E8364B-01C

S E R V I C E N O T E

Supersedes:
E8364B-01B

E8364B PNA Series RF Network Analyzers

Figure 1

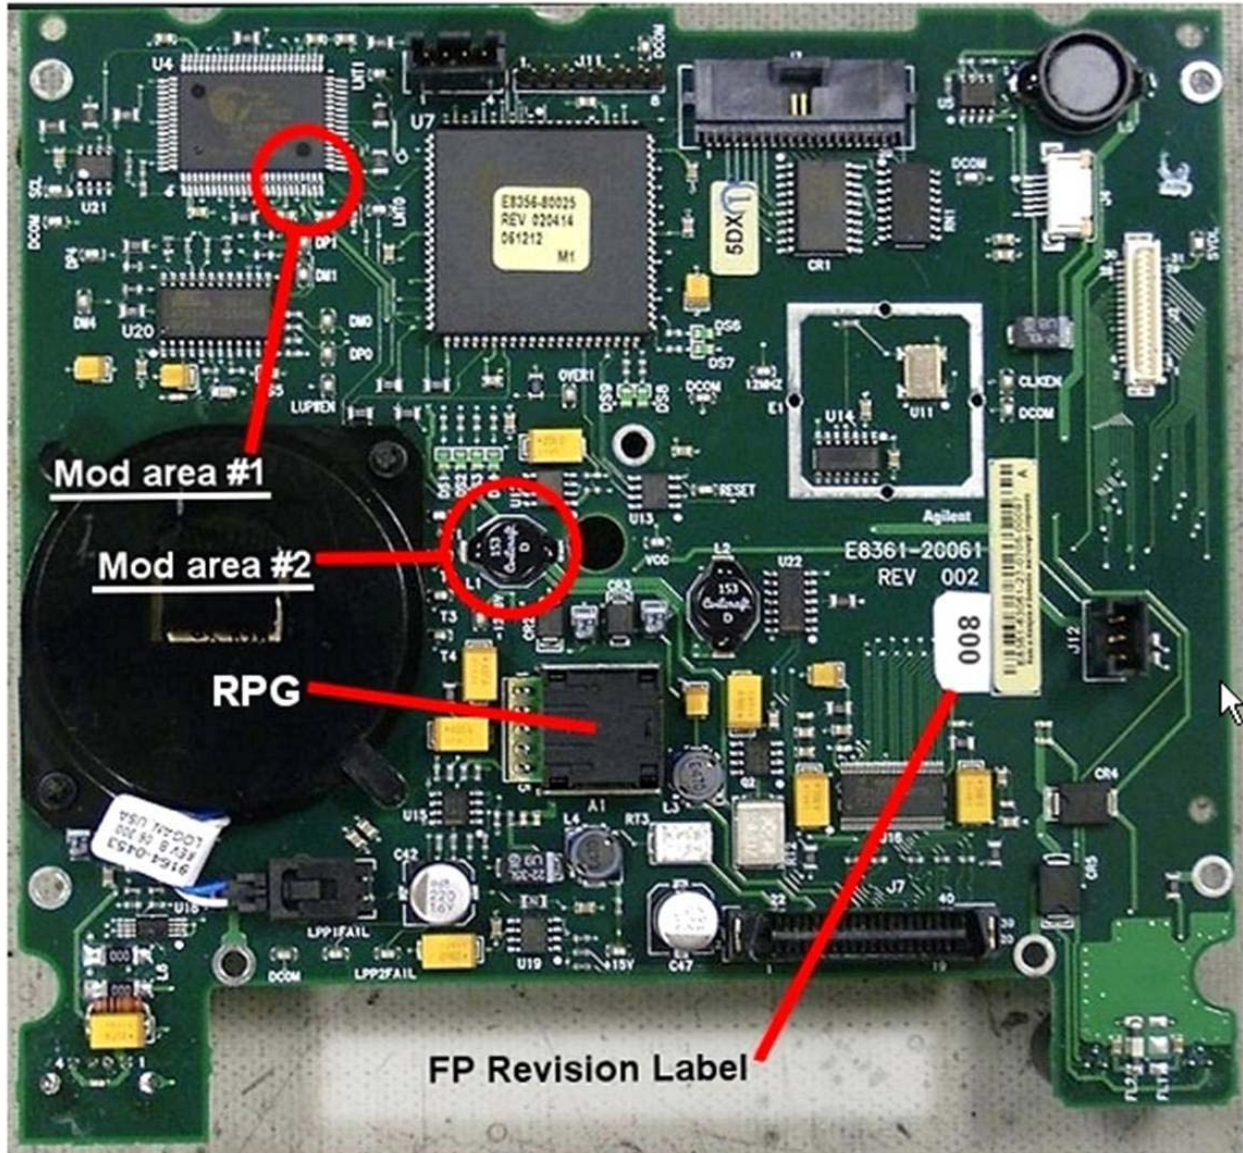
Refer to Figure 1 for the two modification areas to be addressed. Note that while this picture happens to show the FPI board completely removed from the front frame assembly, this is not necessary to perform the required modifications.

- Modification #1 consists of shorting two pins of U4 together with a small amount of solder.
- Modification #2 consist of removing L1.

Figure 2

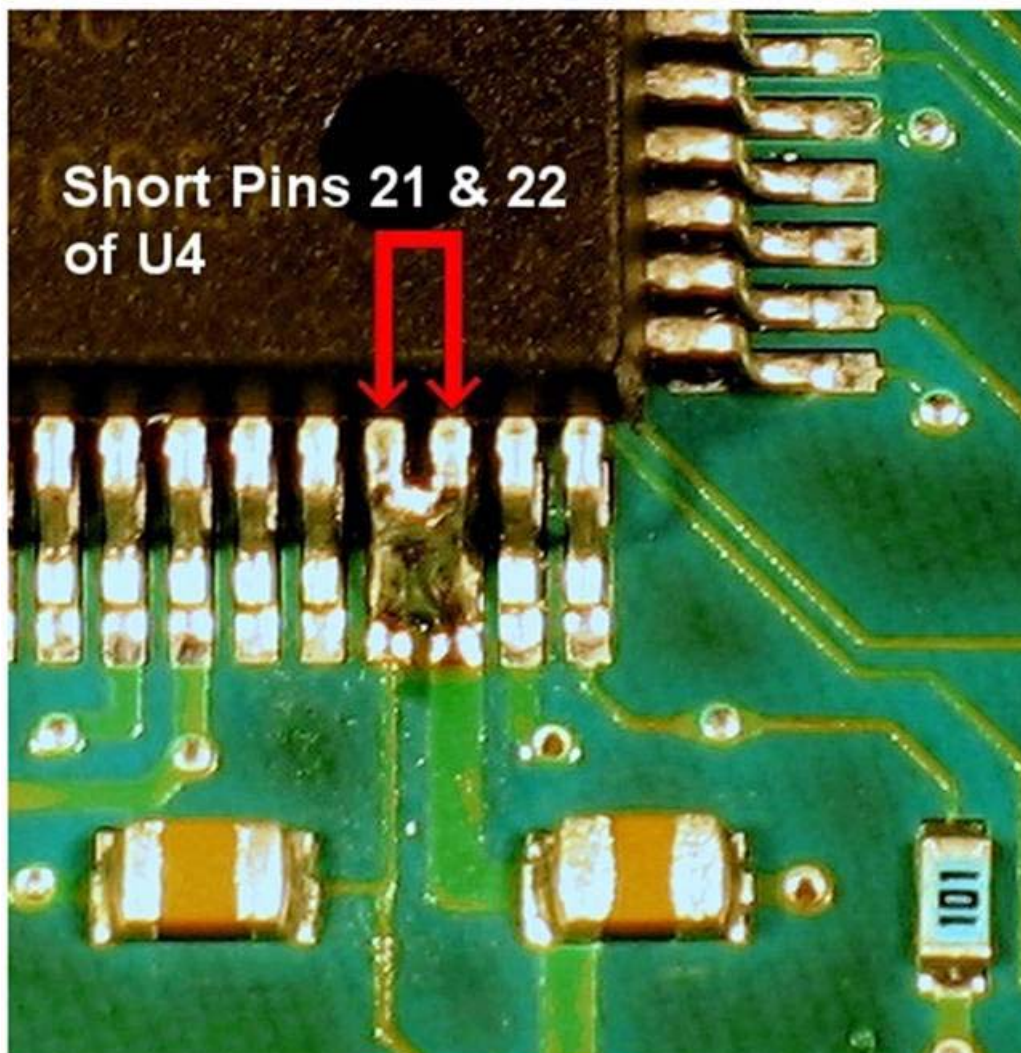
Carefully solder pins 21 and 22 together on U4. Refer to Figure 2 for the exact location. Use care so that no other pins are shorted. Use of a very fine tip soldering iron is recommended and a large work-task magnifying glass is very helpful.

Unsolder and completely remove the black surface mount inductor L1 from the front panel assembly board. This is no longer needed and can be discarded.
